ADDENDUM NO: 01

BID PACKAGE NO: Kitchen Work Rebid

PROJECT: North and South Decatur Jr. / Sr. High School Additions and Renovations

PROJECT NO: DATE: 02/16/2024 BY: Emery H. M. Hunt

DRAWING NUMBER A201

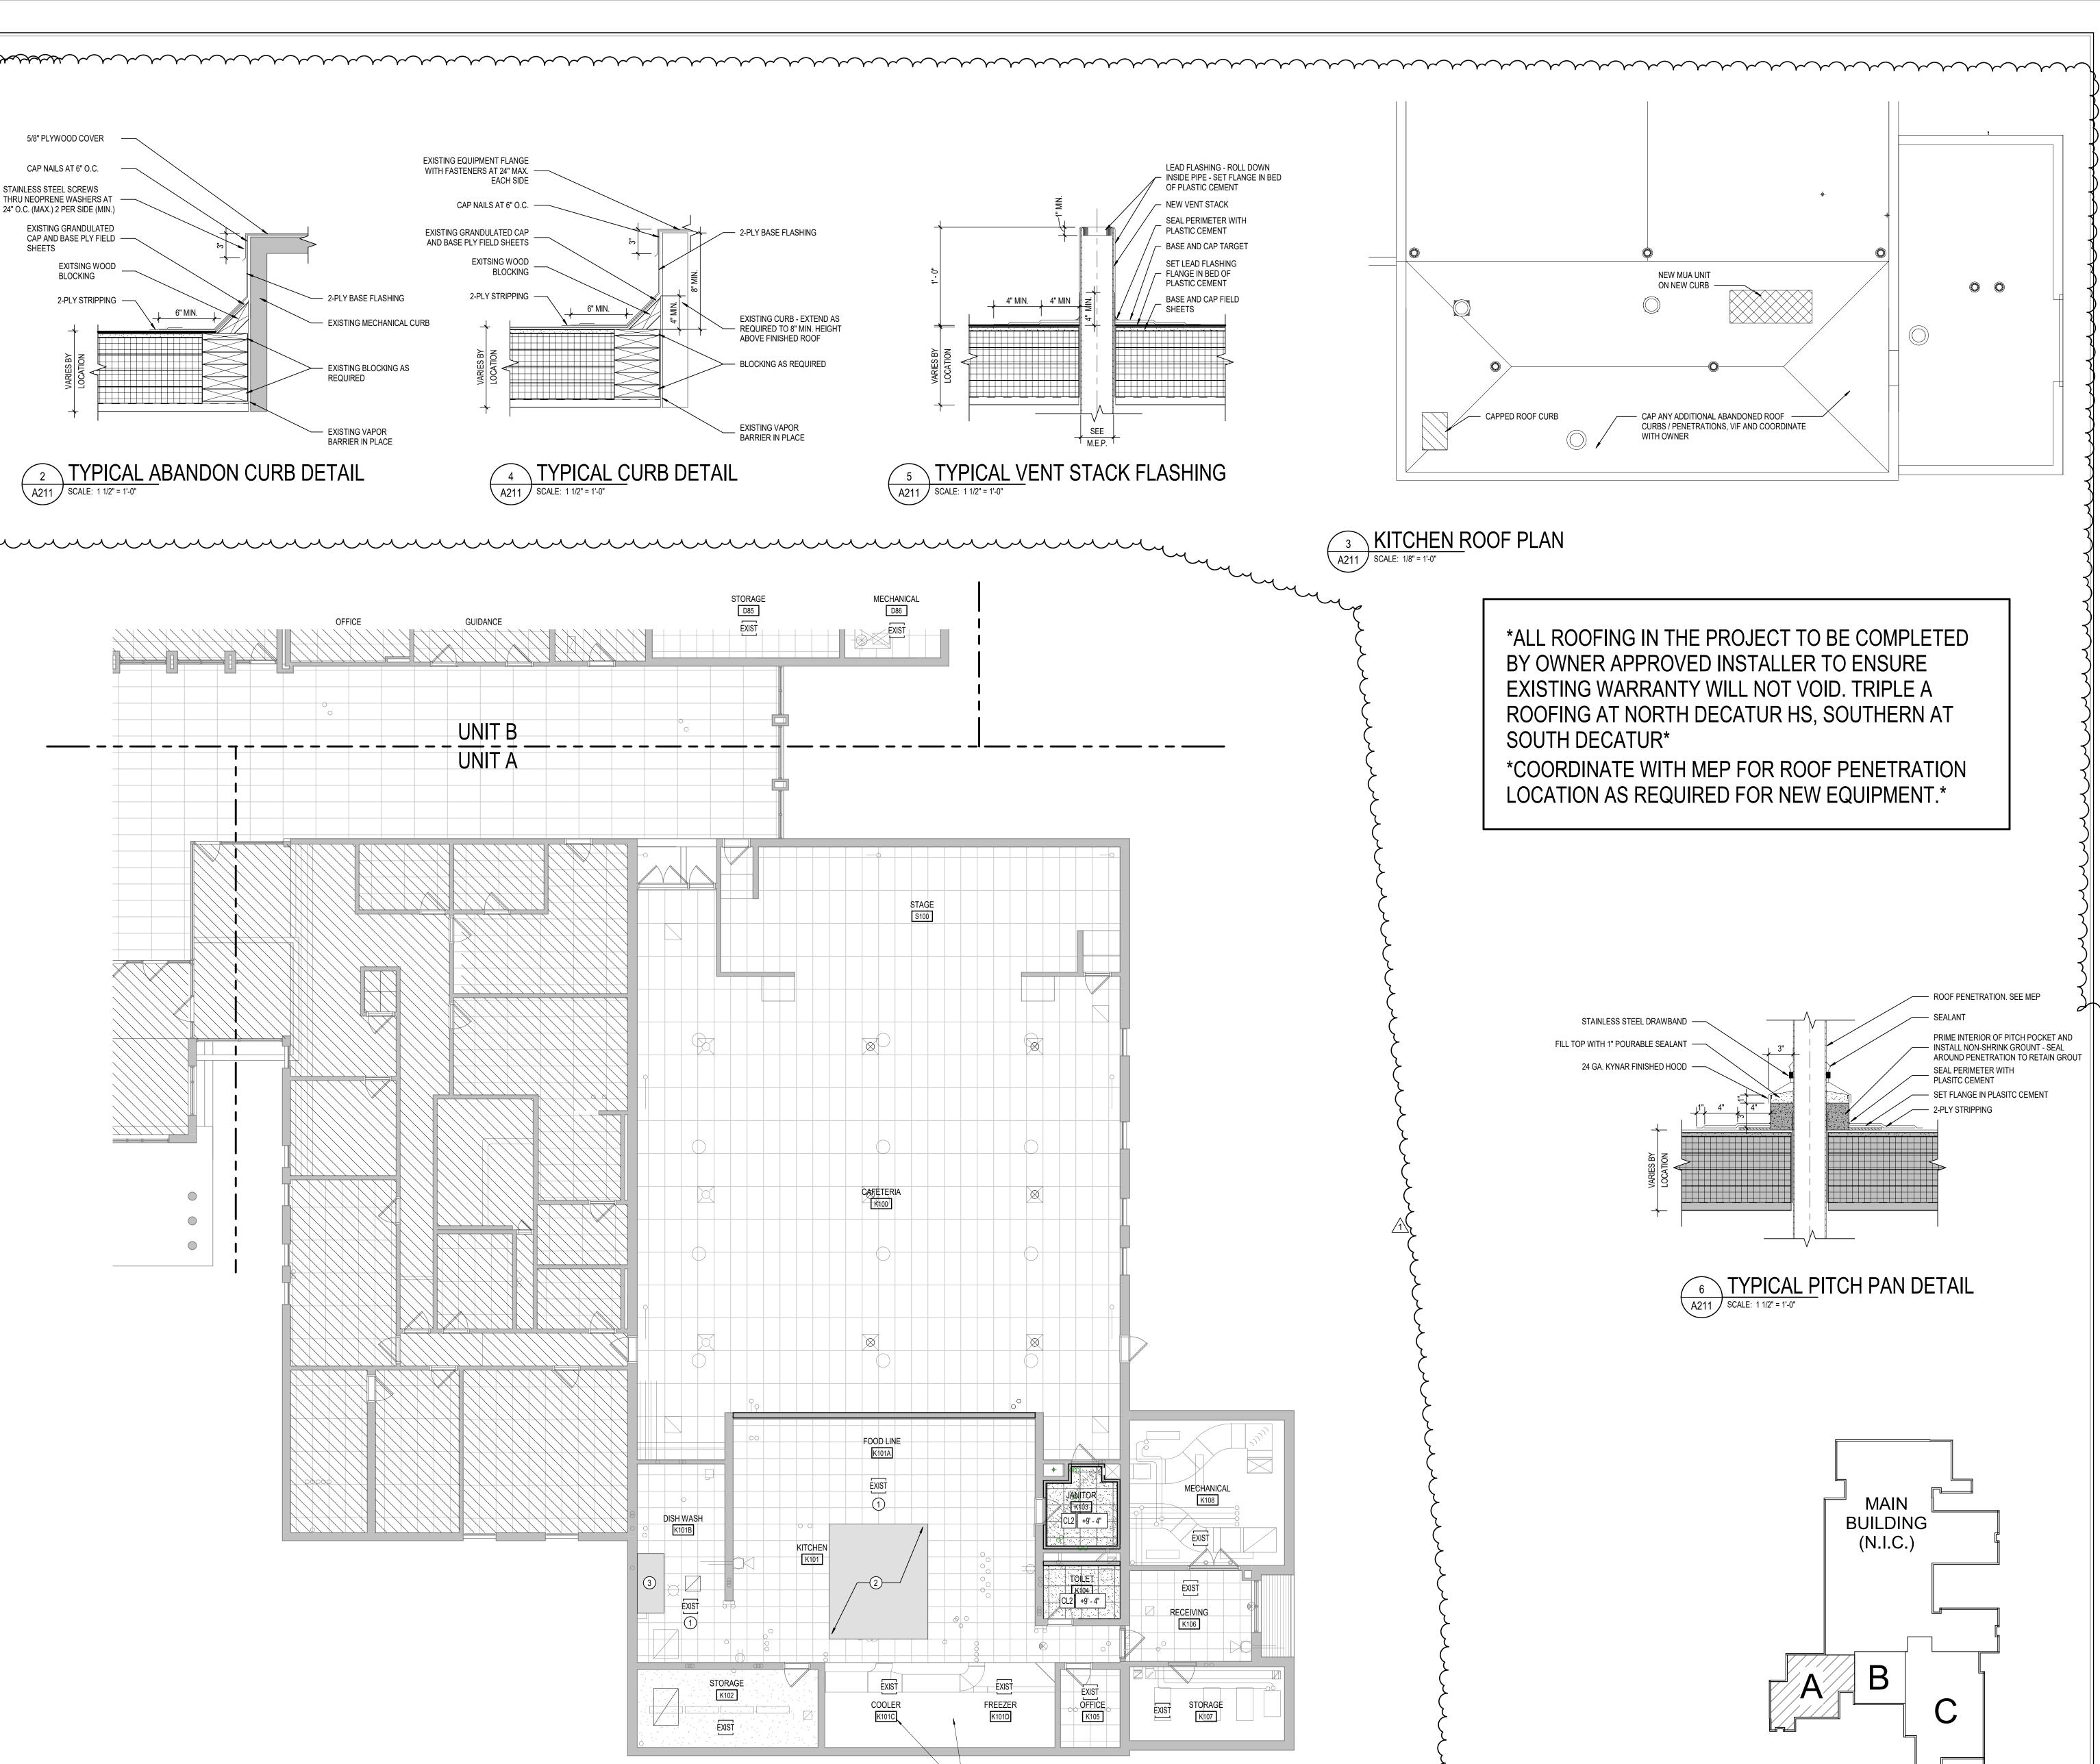
- A. Show alternate bid item for replacement of serving line replacement with new CMU wall and doors.
- B. Revise note 20
- C. Un-tag doors that where shown to receive access control.

A211

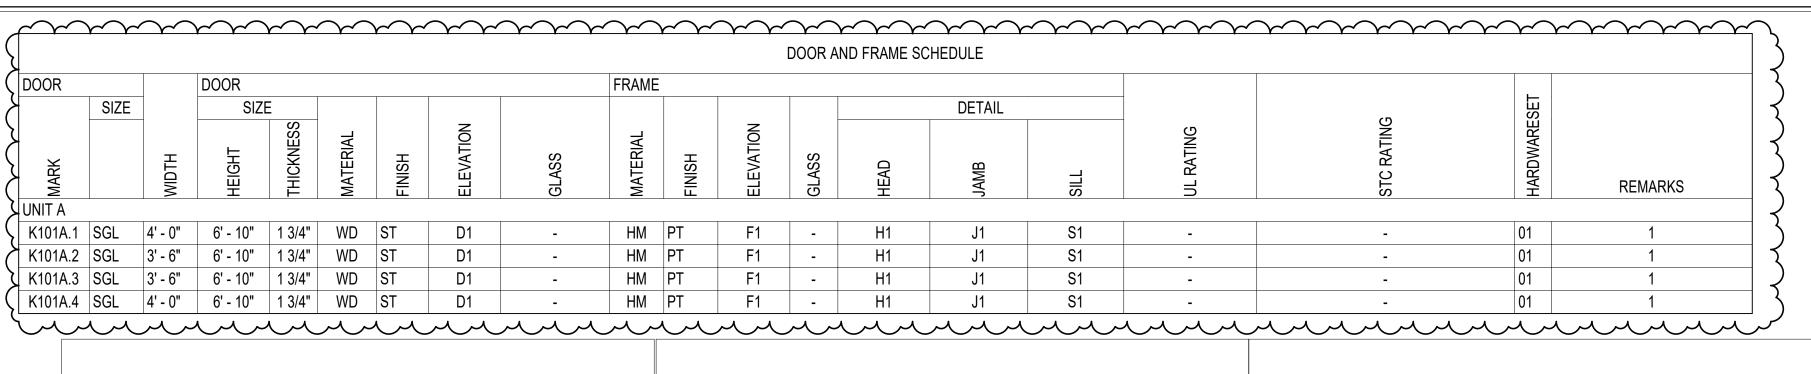
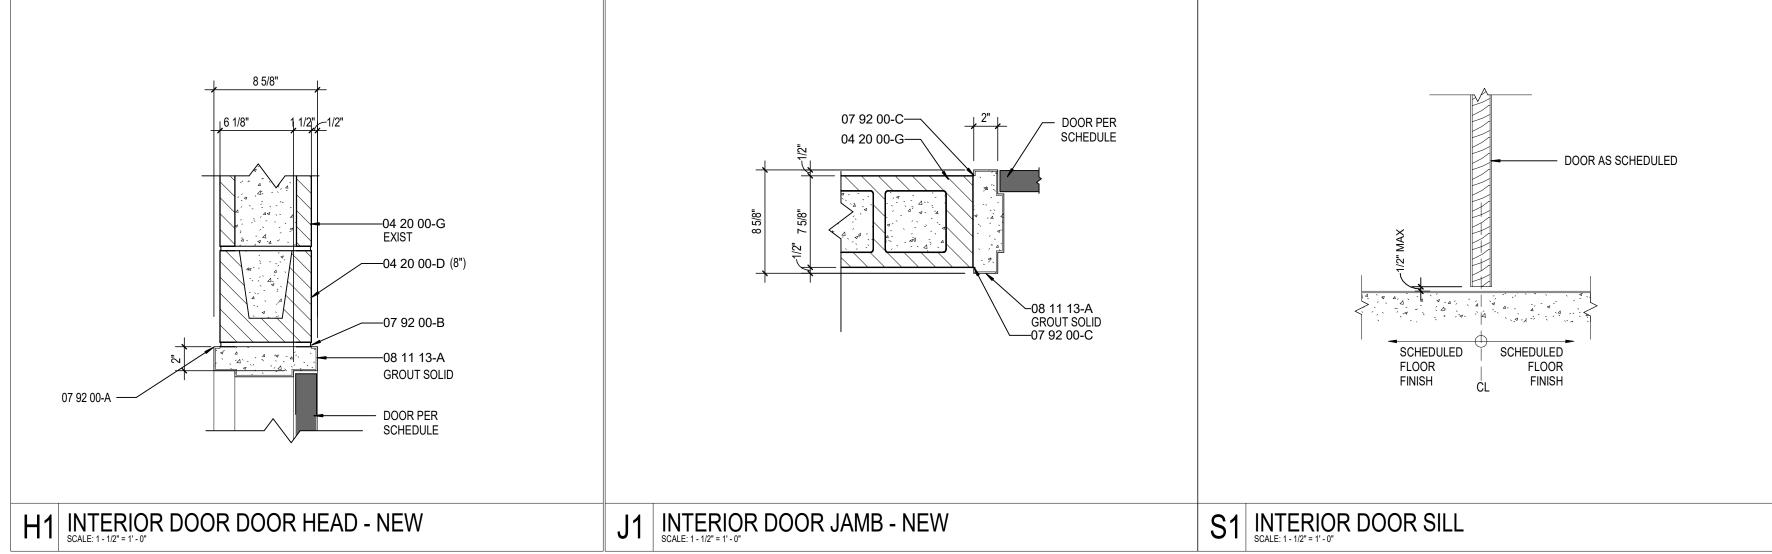
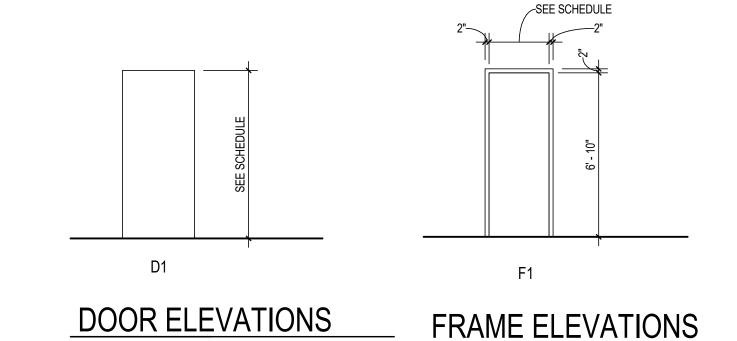
A. Add in roofing plan and typical details to sheet for kitchen roof.

DRAWING NUMBER A501

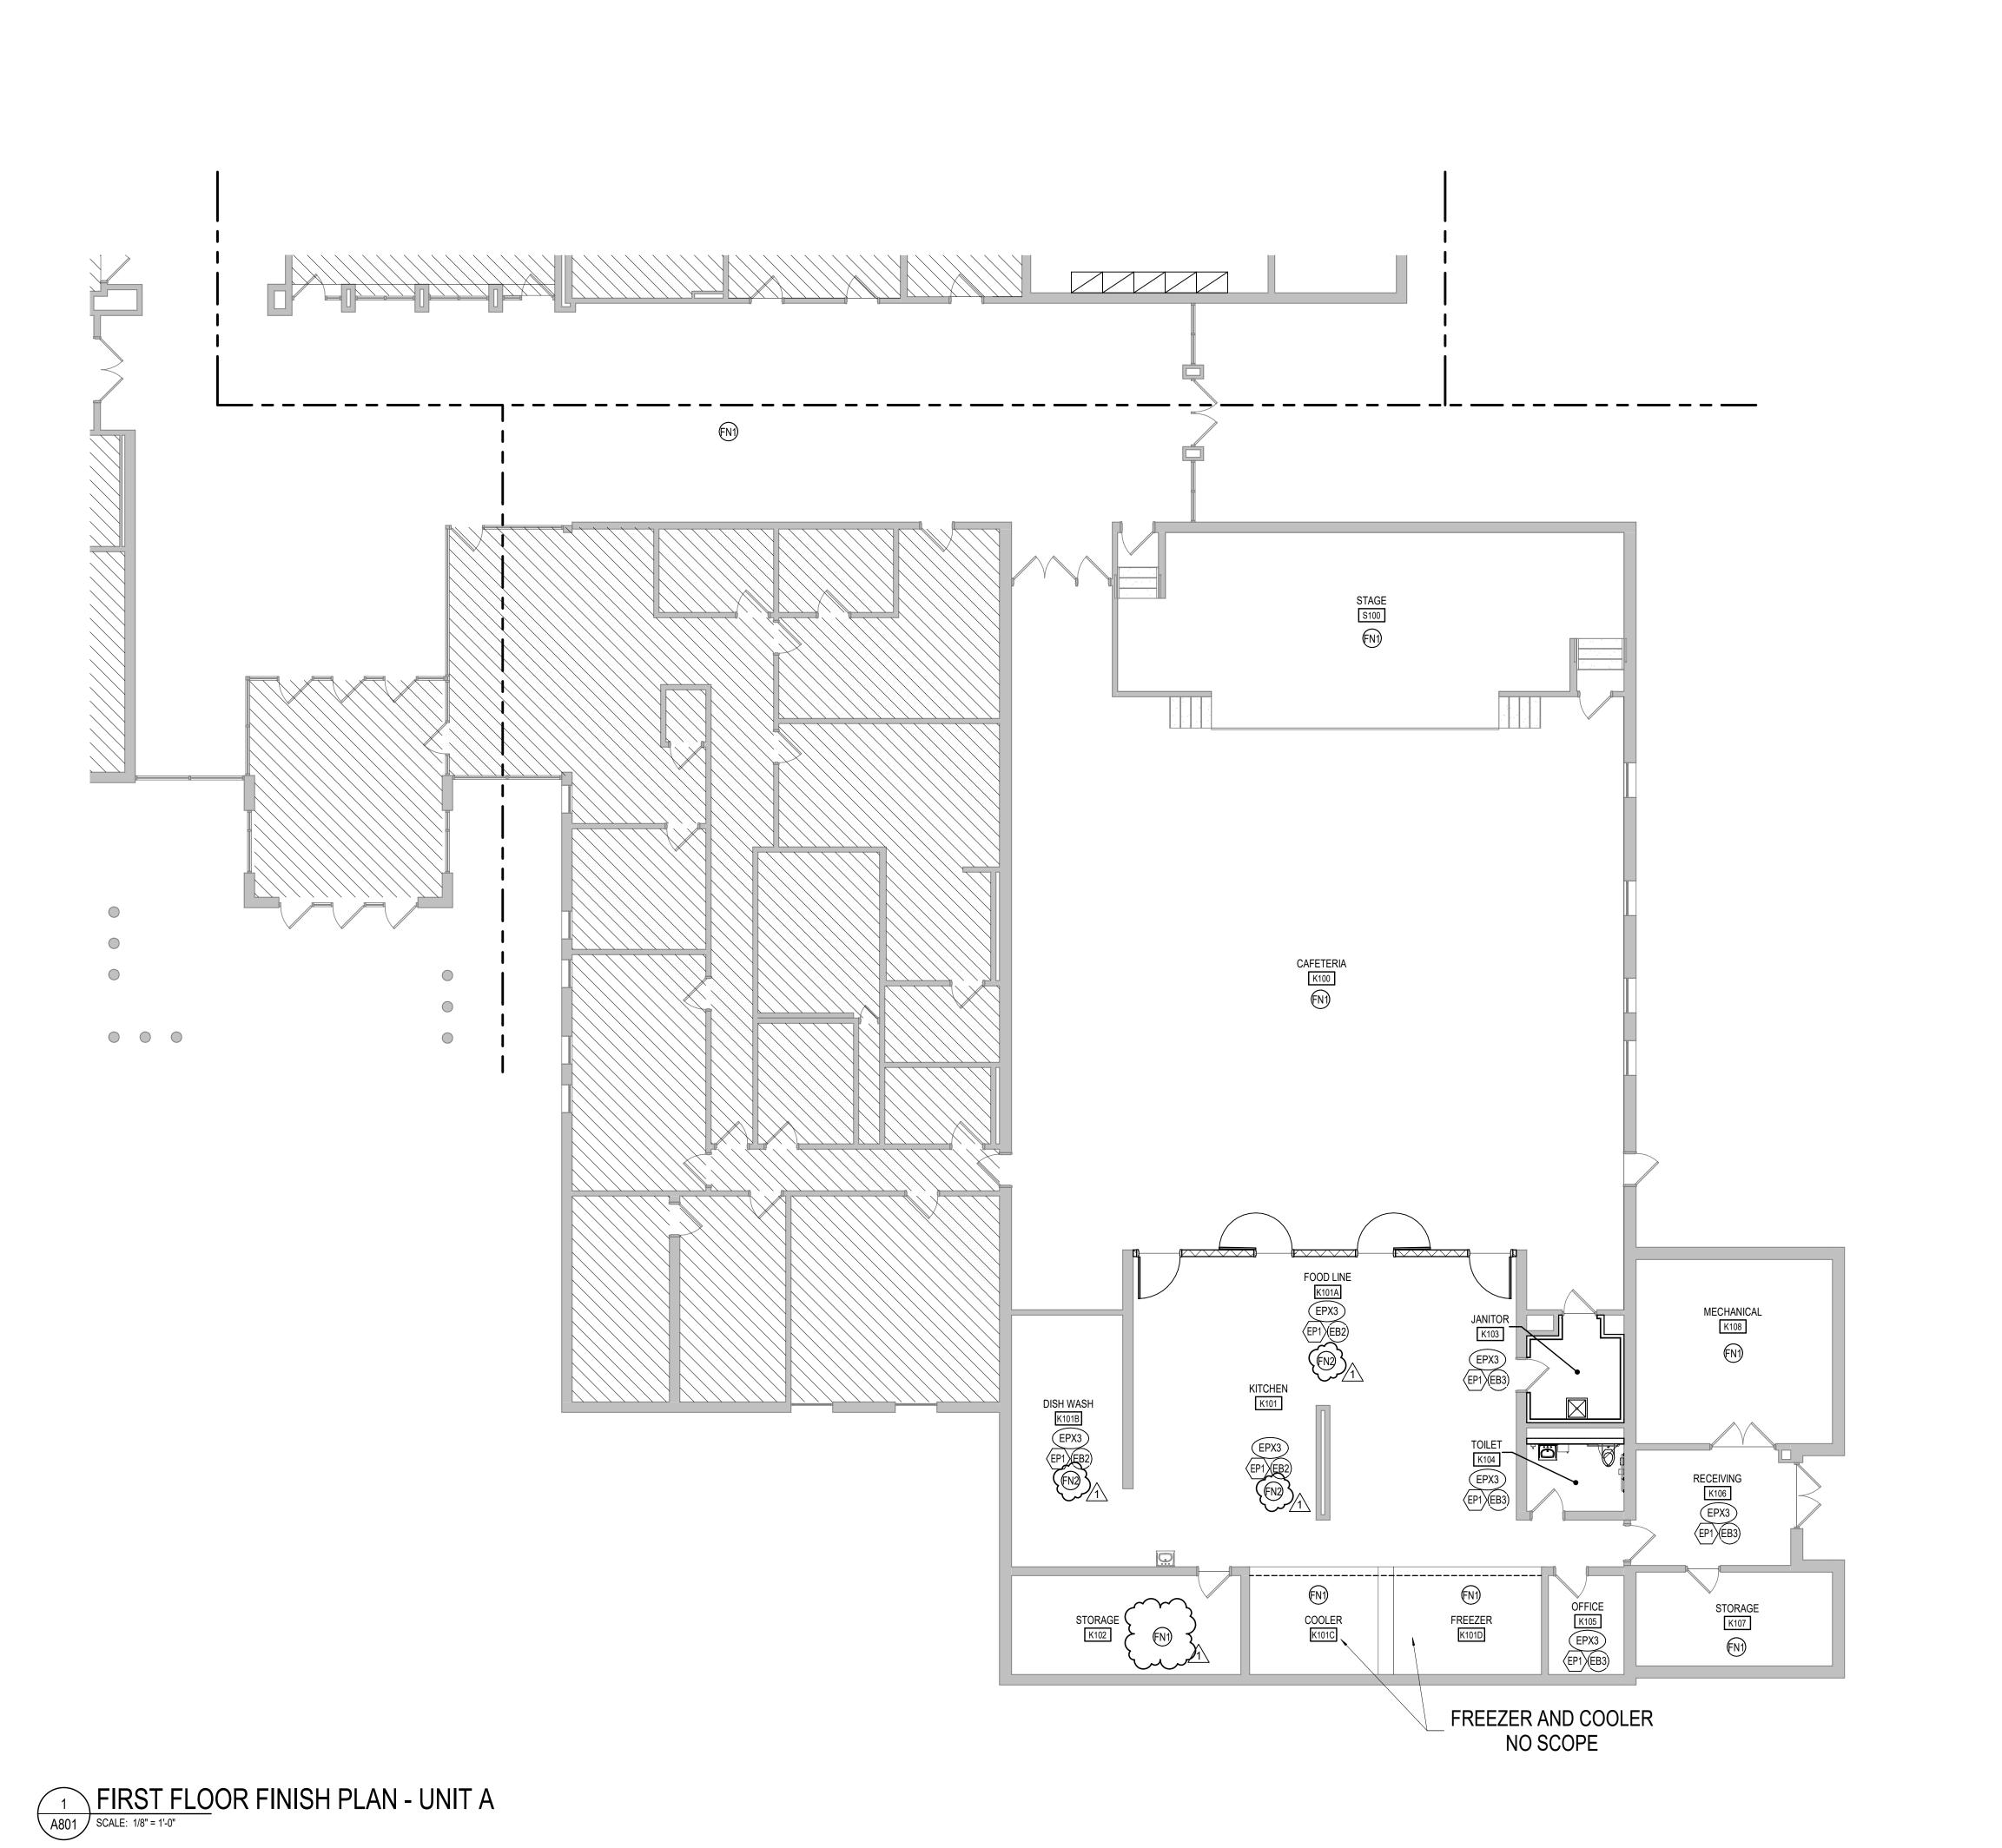
- A. Reissue sheet for new doors in alternate bid.
- B. Revise door remarks as shown.
